STAFF REPORT

Date: June 9, 2023

Re: IWWA Permit Application: Single Family House and Fill in Wetlands

119 Ledgewood Drive

Photo 1, April 4, 2023: Looking west from Ledgewood Drive. Two of the three stakes identifying the southern boundary of the conservation easement, with encroachment of lawn. 107 Stonepost Rd (parcel owner) in background.

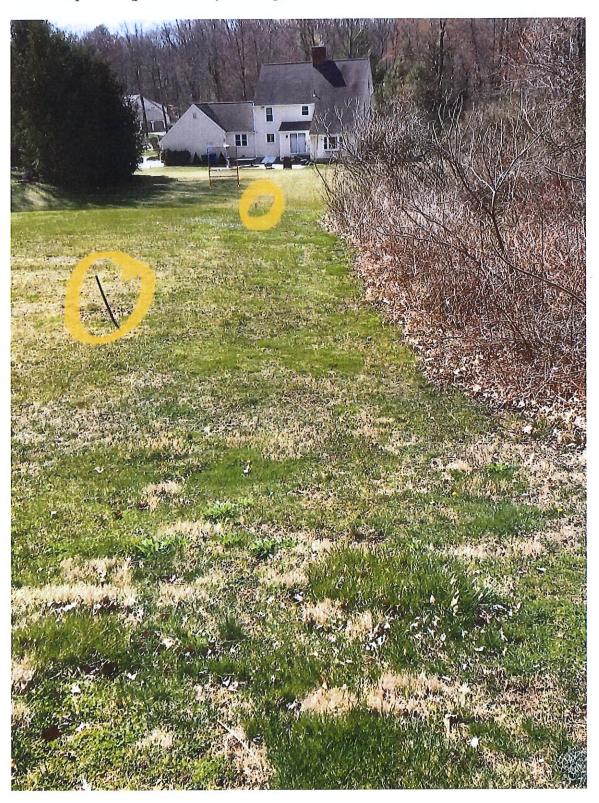
A portion of the conservation easement has been encroached upon with removal of vegetation, deposit of fill and the establishment and maintenance of lawn. The site plan locates the filled area and not the cleared/lawn encroachment. The area of lawn encroachment is not calculated in the application material. The deposit of fill within the conservation easement is listed as a prohibition in the easement document, and the filling of a wetland requires a permit from the Agency. The proposed development plan is silent on the restoration of portion of the encroached conservation easement maintained as lawn.

Placards identifying the boundary of the conservation easement were not observed in the field on April 4, 2023. The proposal does not identify where placards are to be installed.
